RECEIPT DATE: 1/9/17 **ONSITE SEWAGE DISPOSAL SYSTEM** P 560502
 APPROVAL DATE: 2/2/17 ^{SEC} **PERMIT: CONSTRUCTION** A _____
 PROPERTY ADDRESS: 2034 Millers Mill Road
 SUBDIVISION: Millers Mill Development LOT: PAR 22 TAX ID: 04-320018
 CONTRACTOR: Fogle's Septic Clean Inc. EMAIL: zack@foglesinc.com
 CONTRACTOR ADDRESS: 580 Obrecht Road, Sykesville, MD 21784 PHONE: 410-795-5670

RE: BAT Plan
Millers Mill Development
Tax Map: 14, Parcel 22

The following comments apply to the plan prepared by NJR & Associates Land Surveying and Planning Inc. Applicant is advised to revise and resubmit.

SITE PLAN FOR BAT INSTALLATION SHEET 1 OF 1

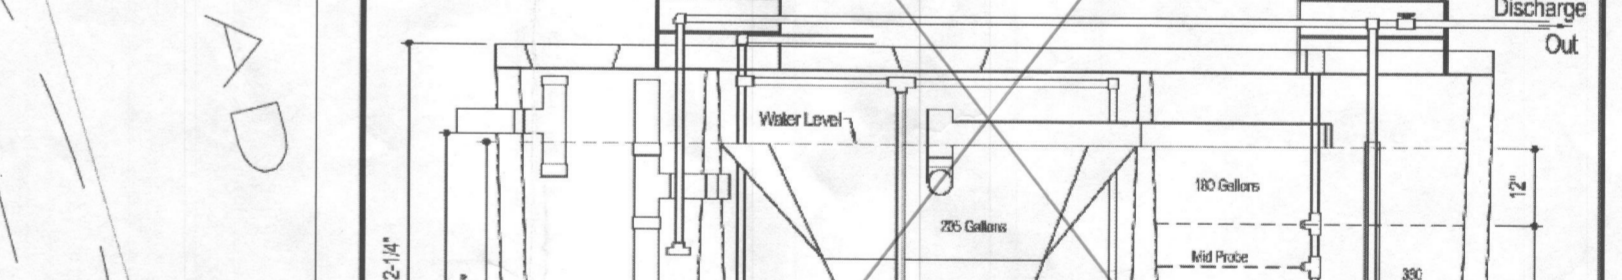
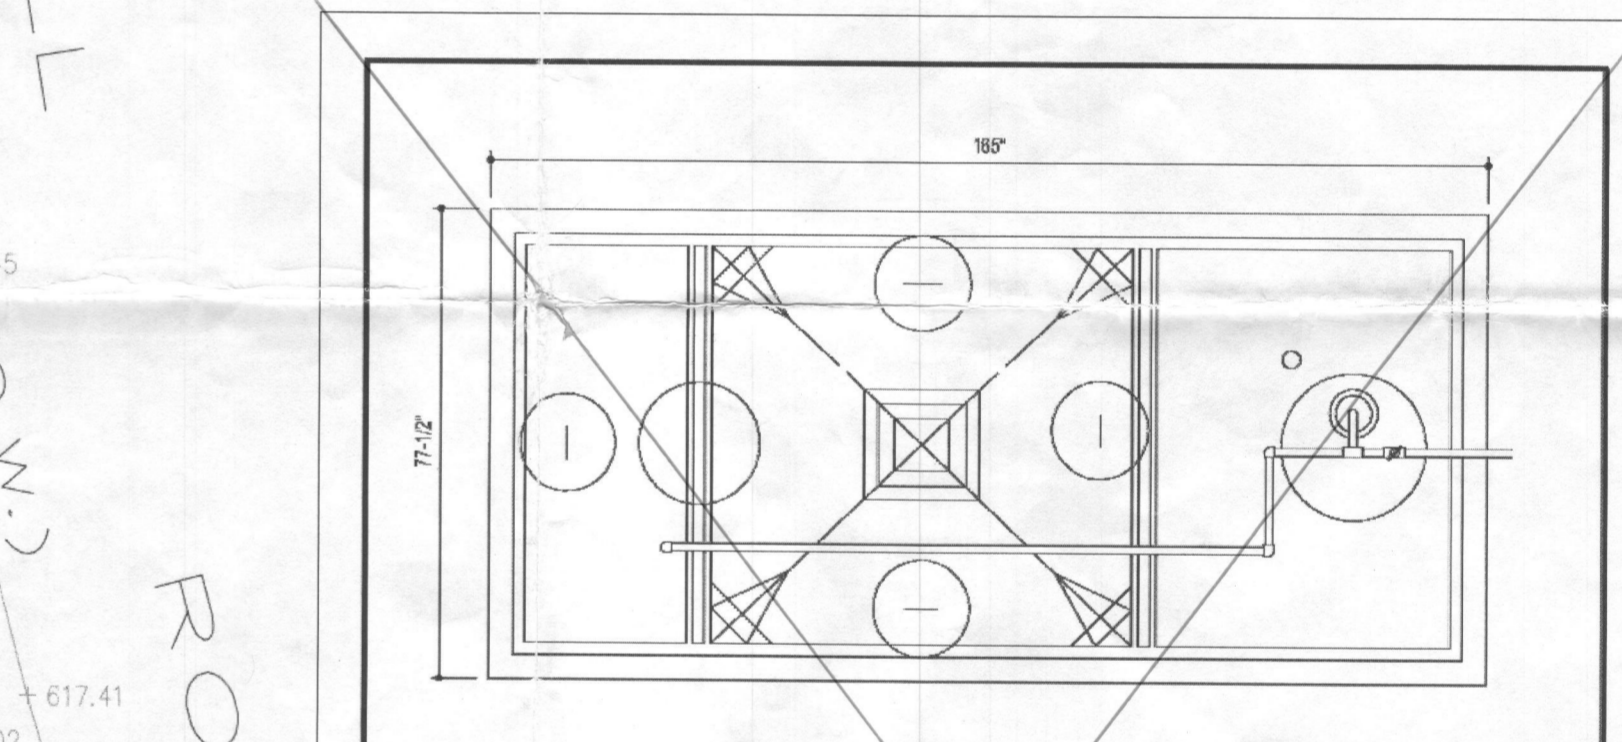
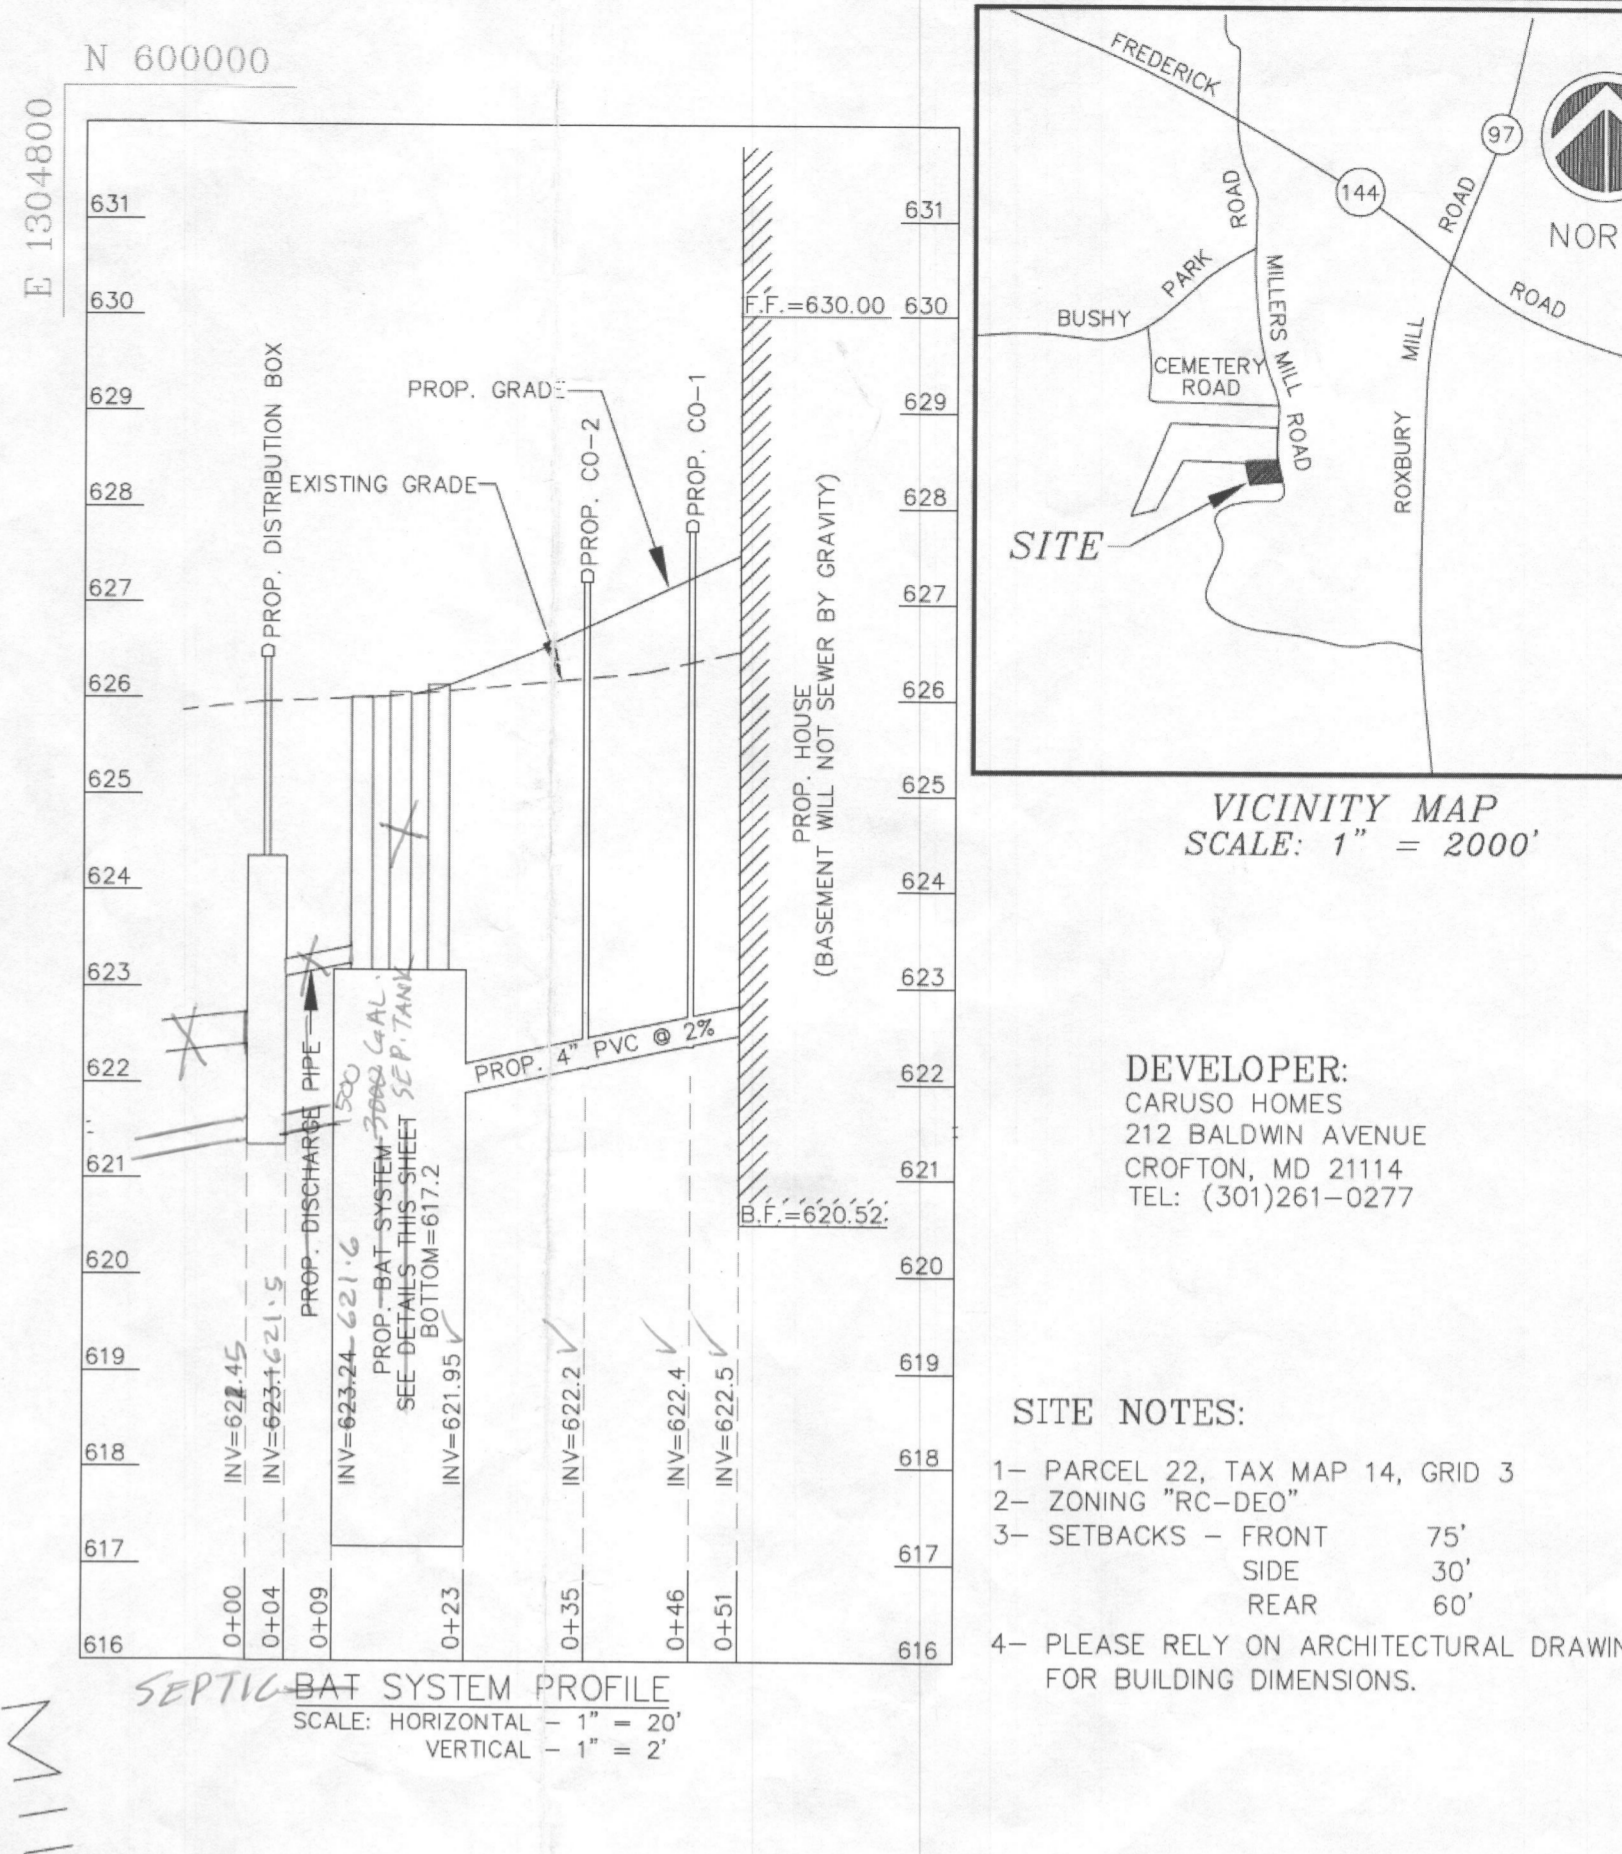
- ✚ Show trenches of equal length. Trench calculations must be shown on plan.
- ✚ Calculations for the initial system and the first replacement must be shown on the plan.

- ✚ The floor plans submitted show 5 bedrooms, with possibly 6. Make sure that your calculations reflect this number of bedrooms.
- ✚ Show septic data on the plan.

- ✚ Title on BAT plan should be stated in the title box.
- ✚ Include a profile drawing with all invert elevations necessary for installation.
- ✚ Show existing septic easement with components, trenches and tank to be abandoned.

- ✚ A legend must be included on plan. All symbols used must be shown on the plan.
- ✚ The existing well and the abandoned well symbols must be shown in the legend. The well must be abandoned prior to BAT approval and documentation must be sent to the Howard County Health Department.

- ⬇ The private easement sewage statement which is located in the right hand corner of the proposed BAT plan should be in the general notes.

1-	REVISED AS PER HCHD COMMENTS, 9/19/2016.
2-	REVISED AS PER HCHD COMMENTS, 10/30/2016.
3-	NEW WELL TAG NUMBER & RAIN GARDEN 2 TO OSDS SETBACK ADDED, 10/30/2016.

RED LINE REVISIONS BY NJR & Assoc. 12/22/2016

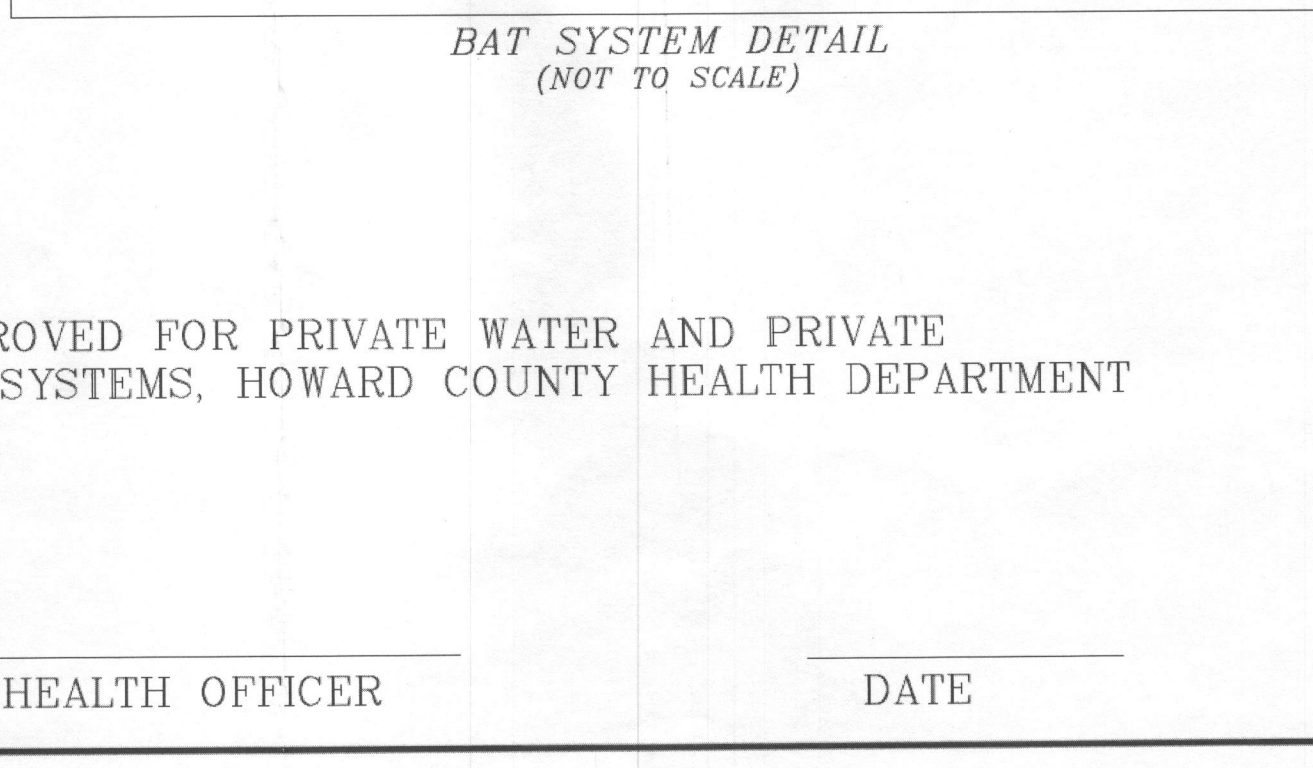
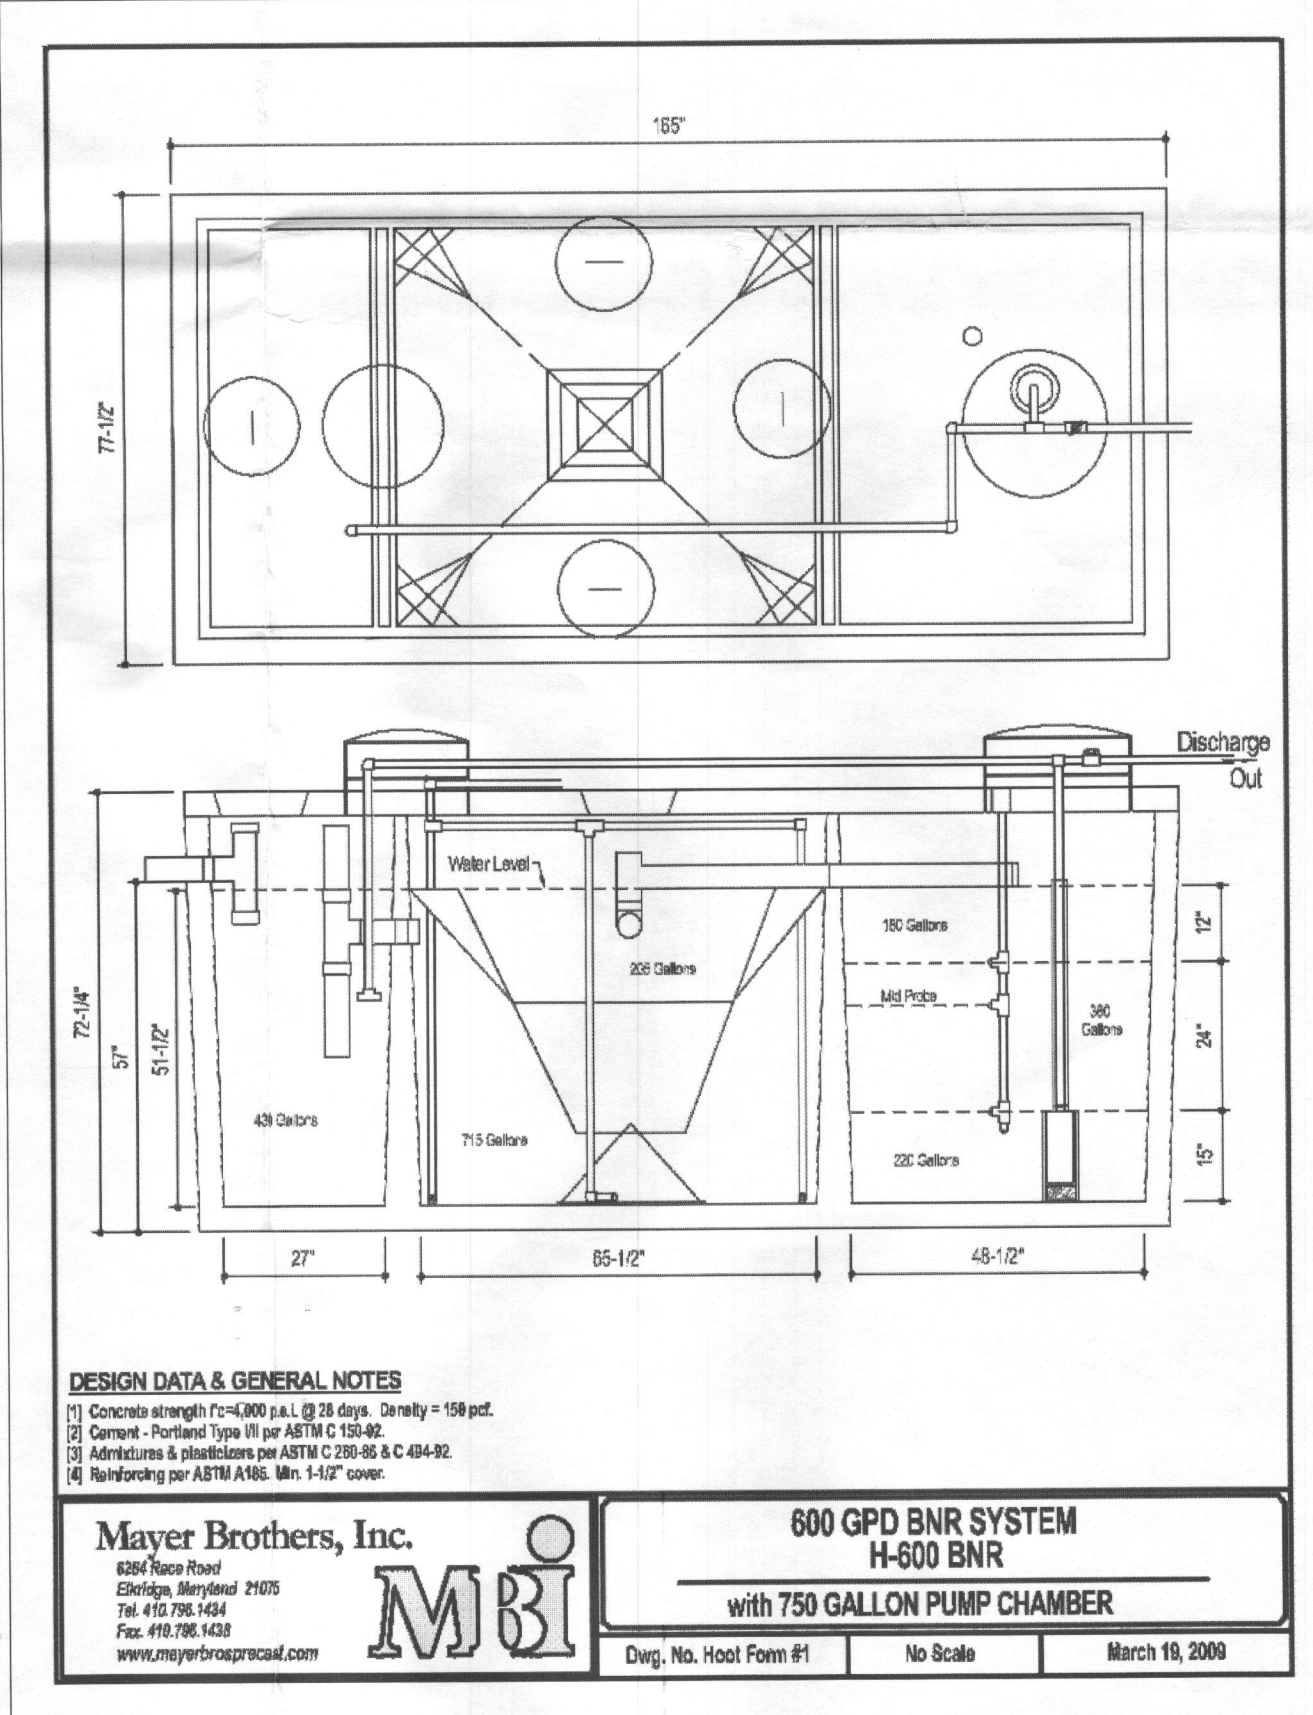
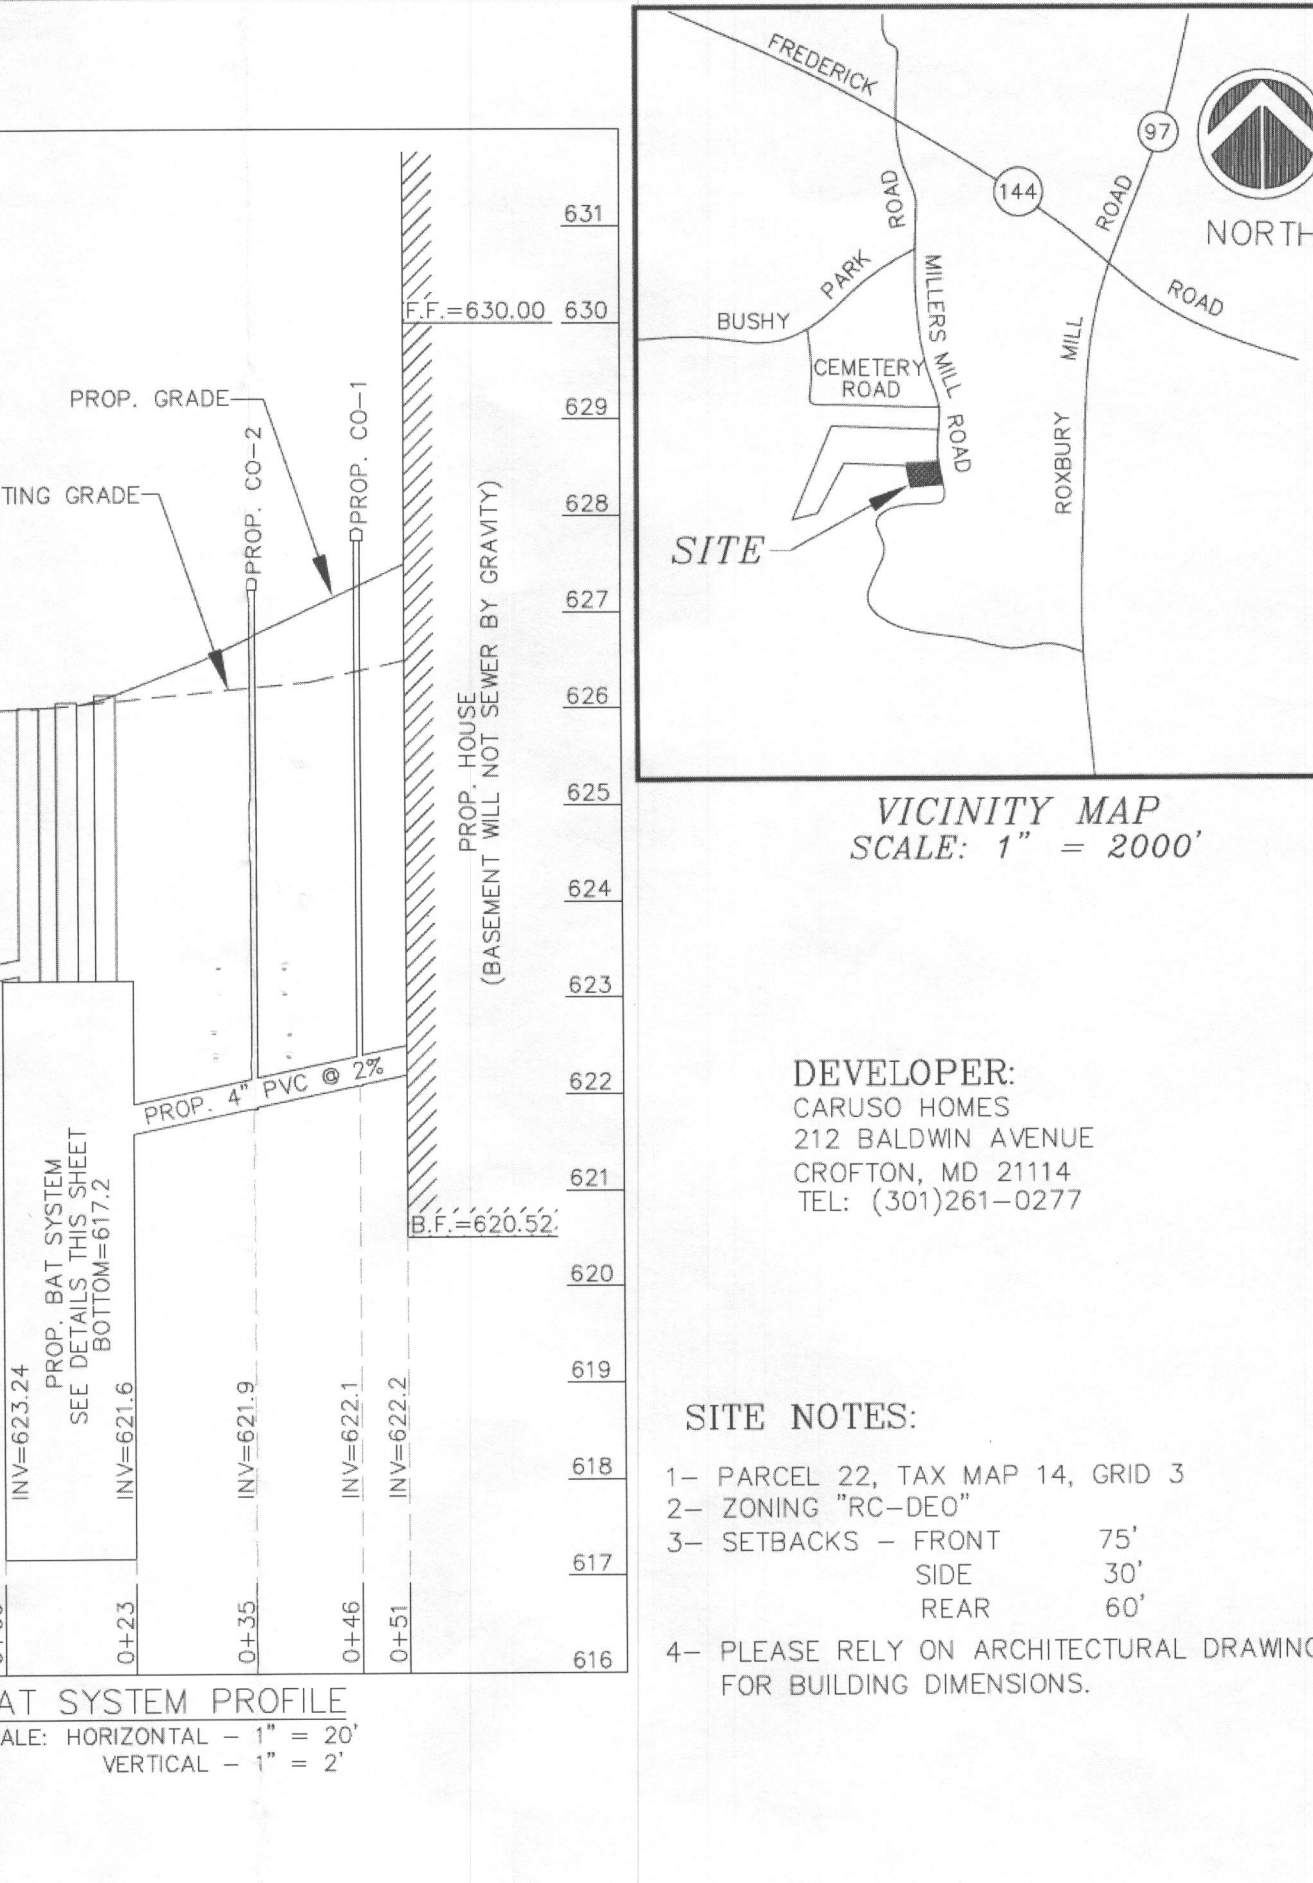
At this point, we can put this email in the file as proof of your intentions and redline it ourselves to be a 1500g tank. I believe the engineer did the original redline. Thanks
Jeff

Greg: we got a call from a contractor asking about the specs for the Millers Mill septic system. In doing that, we noticed that the engineer changed the BAT to a 3000 gallon septic tank. This would be a very large and custom built tank. A 1500 gallon tank would meet our size requirements for a 5 bedroom house. I wanted to double check whether you wanted such a greatly oversized tank. Thanks
Jeff
